SUB-COMMITTEE ON STABILITY AND
LOAD LINES AND ON FISHING VESSELS
SAFETY
55th session
Agenda item 9

SLF 55/9/2
14 December 2012
Original: ENGLISH

**DEVELOPMENT OF PROVISIONS TO ENSURE THE INTEGRITY AND UNIFORM
IMPLEMENTATION OF THE 1969 TM CONVENTION**

Comments on the report of the correspondence group

Figure 1

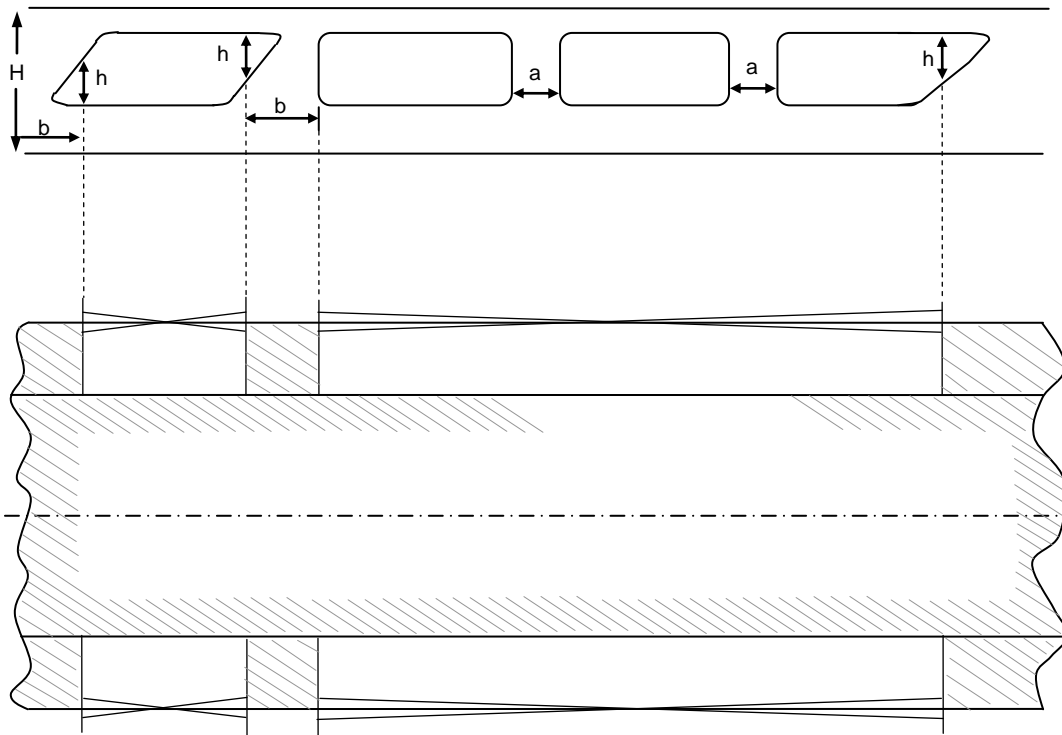
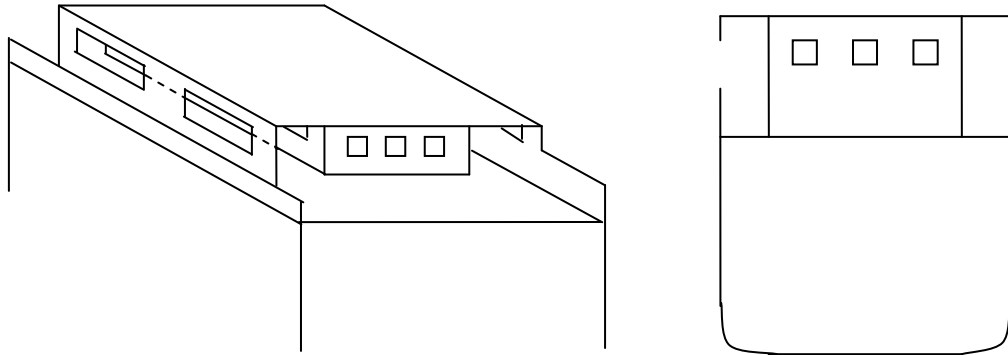
4 Document SLF 55/INF.2, annex 3, page 19, issue 5.i. IACS would like to offer a third proposal as follows: "If the vertical plates or other similar supporting structures along the line of the exposed sides under an overhead deck exceed [0.60 m]/[1 frame] the portion of space protected by such structures should be included in the total volume of all enclosed spaces (V), see figure 1". A version of figure 1 is provided at the annex to this document.
